SC&A Review of SEC-00188 Evaluation Report Addendum 2 for Sandia National Laboratories – Albuquerque

Advisory Board on Radiation and Worker Health, Sandia
National Laboratory – Albuquerque, Work Group

March 3, 2022

SC&A review of SEC-00188 ER Addendum 2

Observation 6: Fluctuations by year

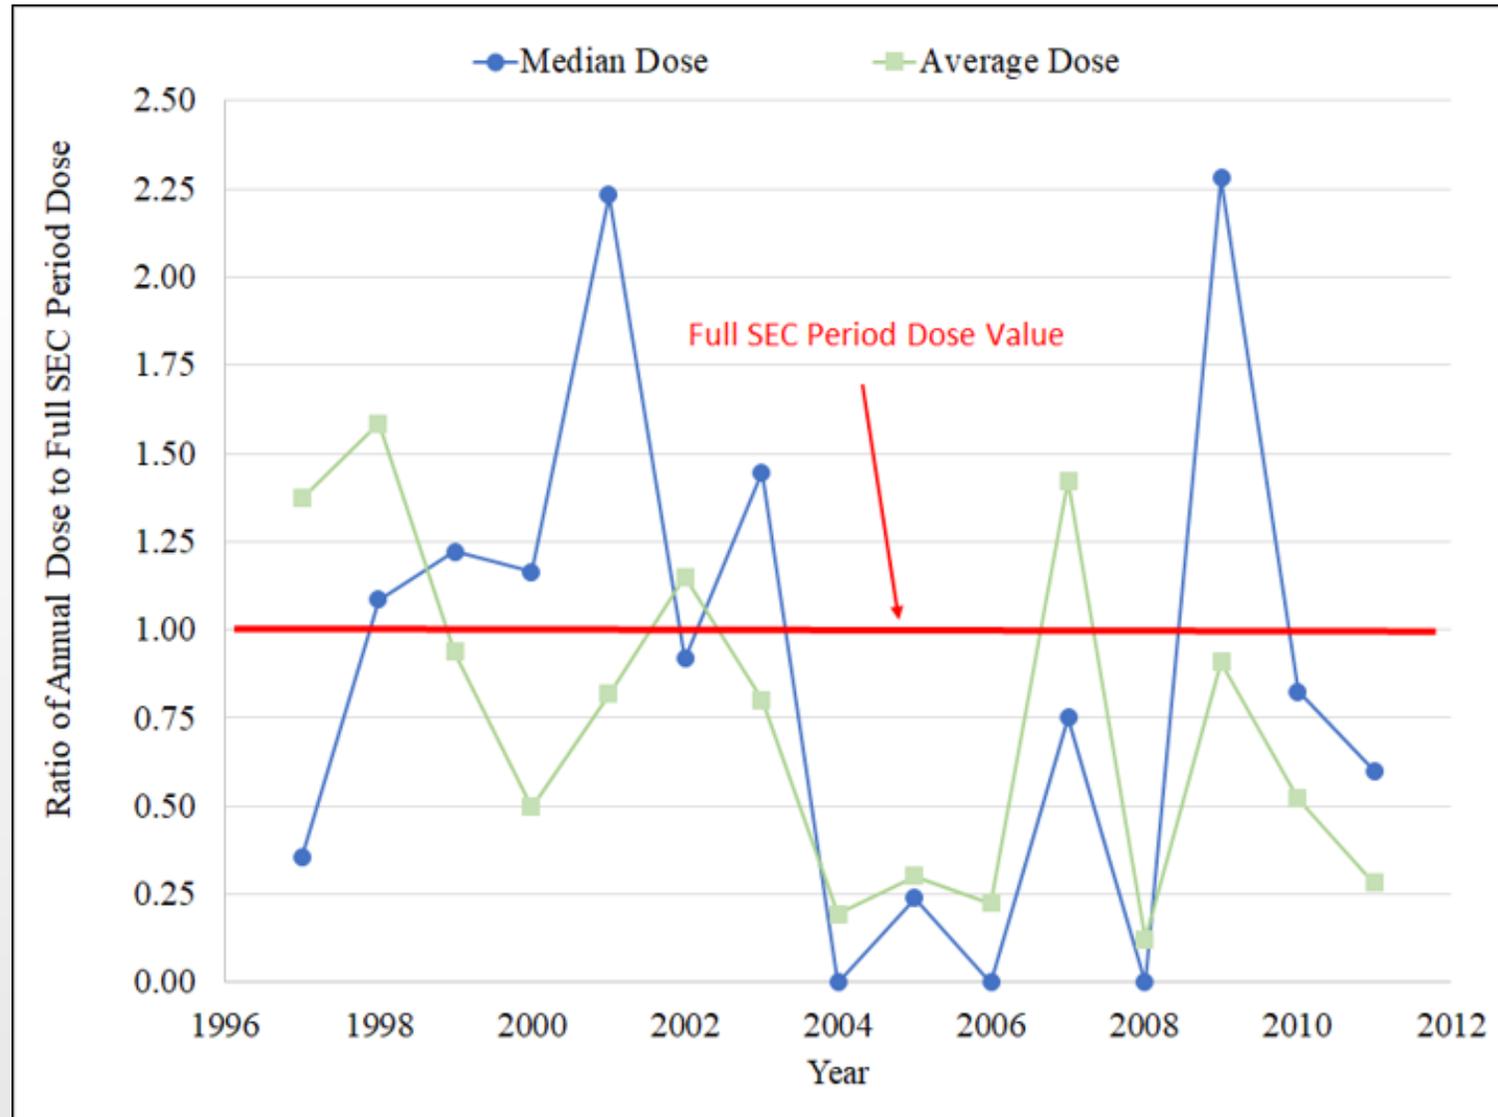
◆ SC&A:

- SC&A's analysis of relative exposure potential demonstrates that noteworthy fluctuations in exposure potential can exist by year and by work area.
- SC&A does not believe these fluctuations necessarily obviate the use of 100 mrem as a maximizing dose assignment to unmonitored workers, as several significantly conservative assumptions were included in the dose estimates. (SC&A, 2020, pp. 35–36)

- ◆ **NIOSH:** NIOSH concurs with the observation and does not believe these fluctuations obviate the use of 100 mrem as a maximizing dose assignment to unmonitored workers.
- ◆ **SC&A reply and recommended status:**
 - Based on these mitigating factors, SC&A (2020, 2021) concluded that dose assessment using incomplete BZ data is sufficiently conservative to allow the conclusion that a bounding internal dose estimate of 100 mrem on an annual basis is appropriate for unmonitored or partially monitored workers.
 - Recommend work group closure.
